Subject: Comments of Casitas Municipal Water District on the State Water Resources Control Board (SWRCB) Development of Groundwater-Surface Water and Nitrogen Transport Models of the Ventura River Watershed (Ventura River Watershed Modeling Study)

Comments on California State Water Resources Control Board's Ventura River Watershed Integrated Hydrologic Model

01 April 2022

Figure 10. Observed and simulated groundwater levels at wells located along hydrogeologic cross-section of the Ojai Basin (see Fig. 11)

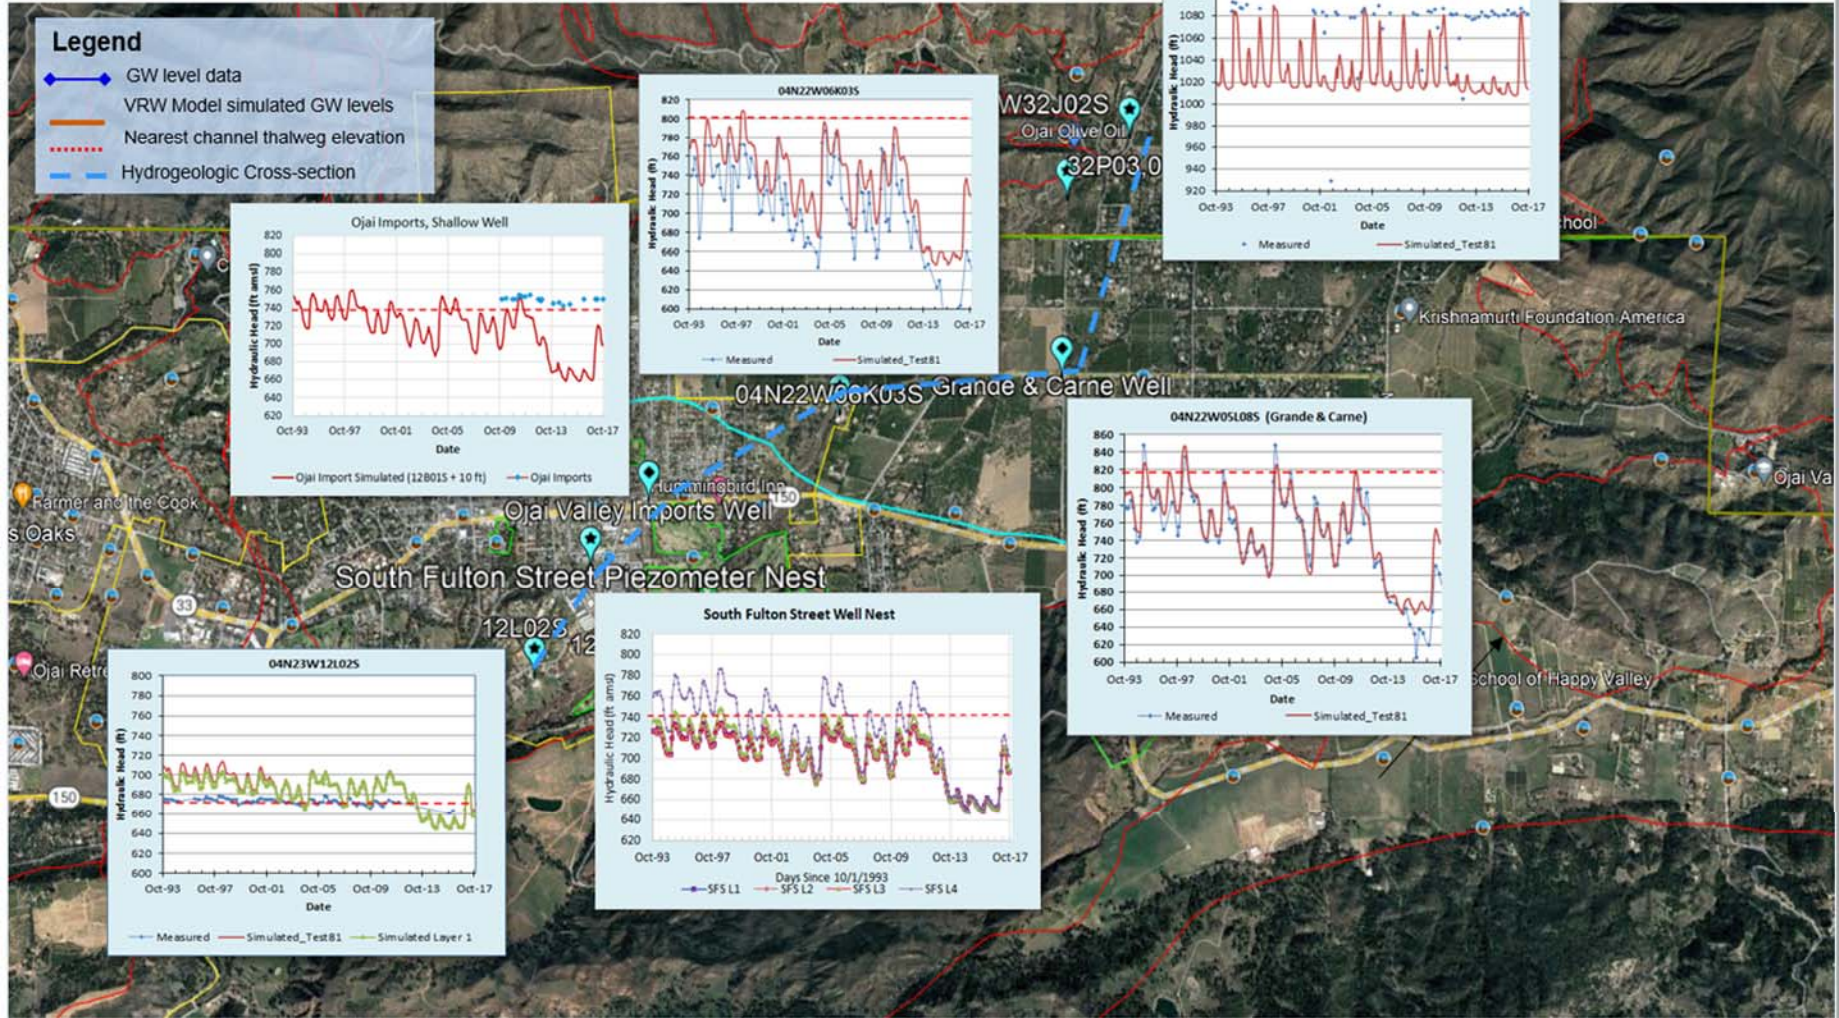
Figures 10 and 11 clearly show the aforementioned behavior of the model poorly simulating the monitoring data from the shallow perched zone, specifically wells 04N23W12L02S, Ojai Imports, and 05N22W32J02S. While only these wells are shown in the cross-section, essentially all shallow wells in the Ojai Basin are similarly poorly simulated.

Shown in the hydrographs in both figures is the thalweg elevation of the nearest stream channel. Also shown schematically in hydrogeologic cross-section (**Fig. 11**) is the approximate location of the perching layer that has been observed across the southwest third of the basin. These two features are important in identifying the model structural error in the Ojai Basin, and how that structural error impacts surface water – groundwater interaction calculations. Comparing the observed and simulated groundwater levels to the nearest stream channel elevation shows that:

- in the north-central upper reaches of the basin, measured groundwater levels generally stay well below the stream channel elevation and exhibit unconfined behavior in the groundwater fluctuations, while the model results incorrectly show confined behavior. Thus, those upper reaches are generally losing surface water to groundwater recharge, via infiltration into the stream channel deposits

- in the central portion of the basin, simulated groundwater levels rise above the nearest stream channel elevation during wet periods, and remain below that level during drier periods, indicating the potential for hydraulic gradients both toward and away from the stream depending on hydrologic conditions

- in the southwest portion of the basin (well 04N23W12L02S) the simulated groundwater levels are usually significantly higher than the nearby stream channel elevation, although the measured groundwater levels rarely rise above the stream channel elevation and exhibit low-fluctuations, unconfined behavior as expected in the shallow zone.

Figure 11. Hydrogeologic cross-section from transect illustrated in Fig. 10, showing VRW model layers, and missing confining layer schematically illustrated

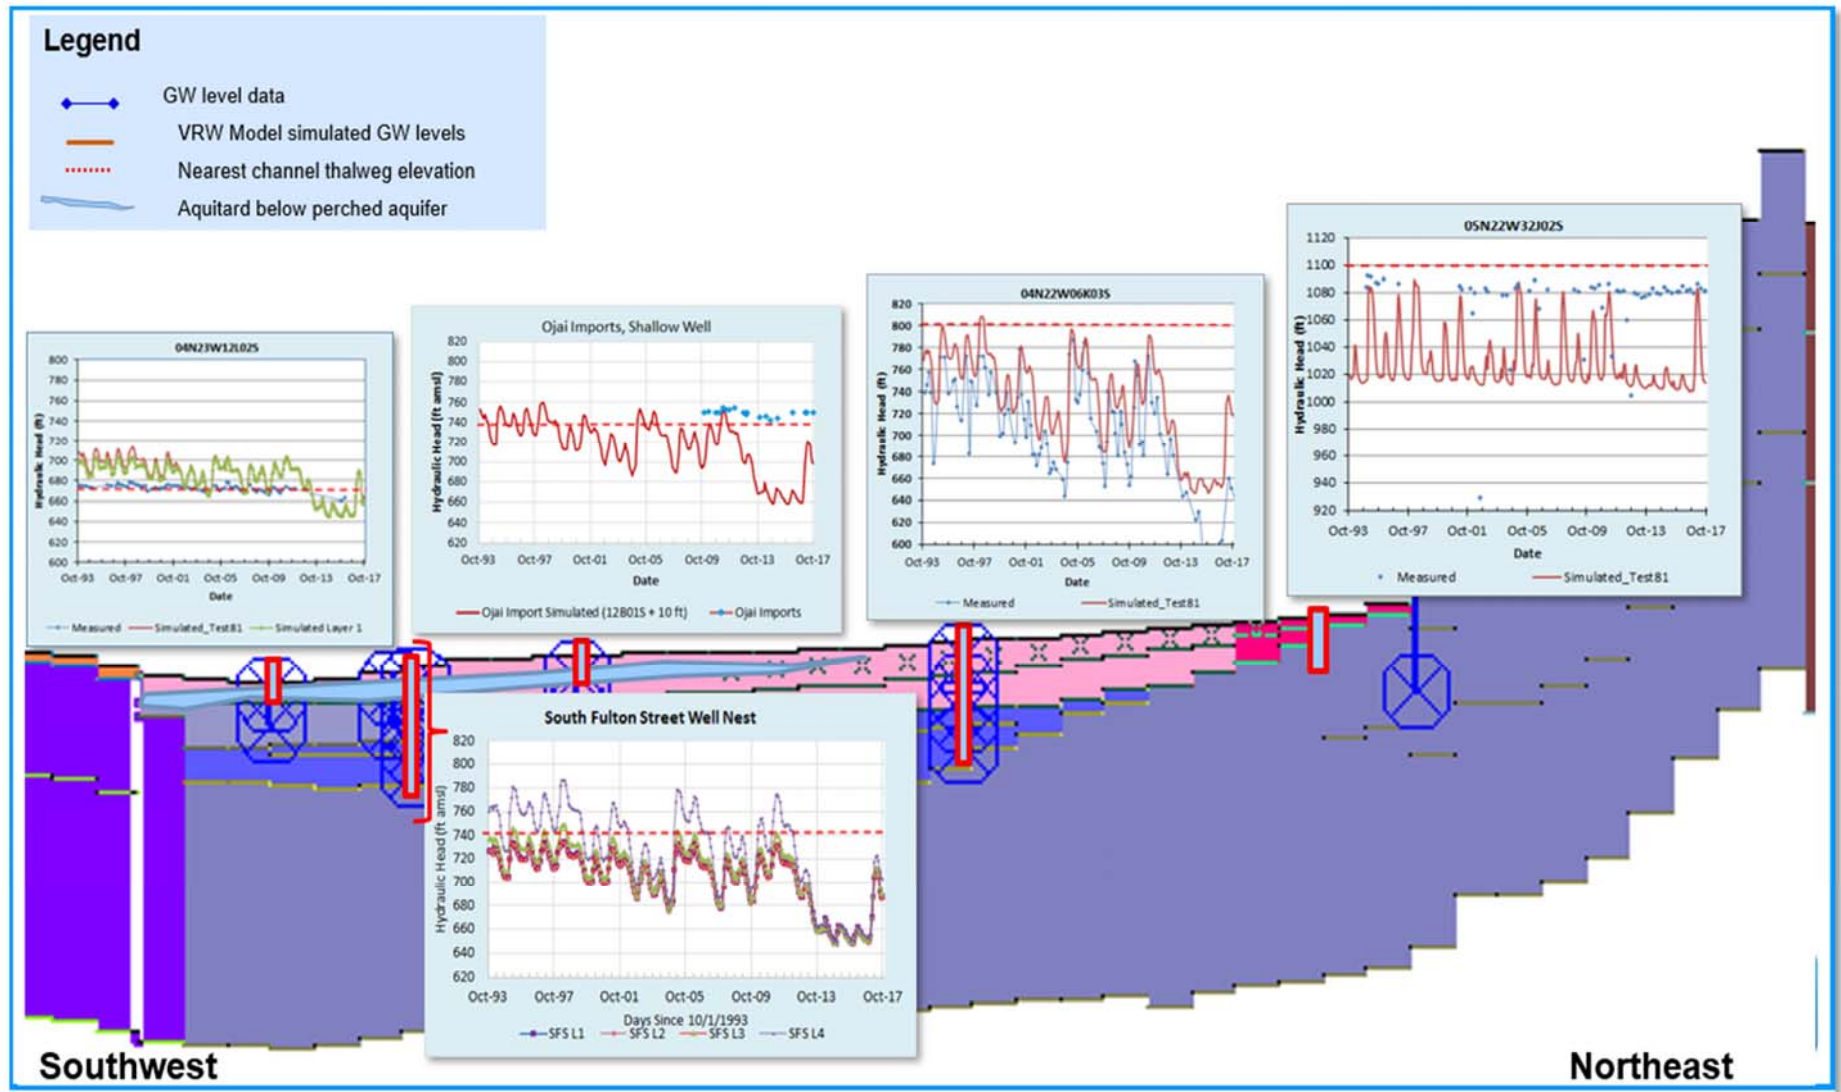
All of these data point to a structural error in the model, stemming from not explicitly simulating the perching / confining layer that is obviously an important stratigraphic layer that controls vertical flow and confining heads in the Ojai basin. These errors in the model of the groundwater system lead to strong simulated baseflow discharge to San Antonio Creek in the southwest portion of the Ojai Basin. However, this southwest portion of the basin is precisely where the extensive perching / confining layer has been mapped, and in reality this confining layer effectively prevent upwelling and discharge of deep groundwater to San Antonio Creek. If this model structural error were corrected by explicitly including the confining layer and the shallow perched system as separate layers in the model, then the simulated groundwater discharge to the surface water system in the Ojai Basin would be significantly reduced.
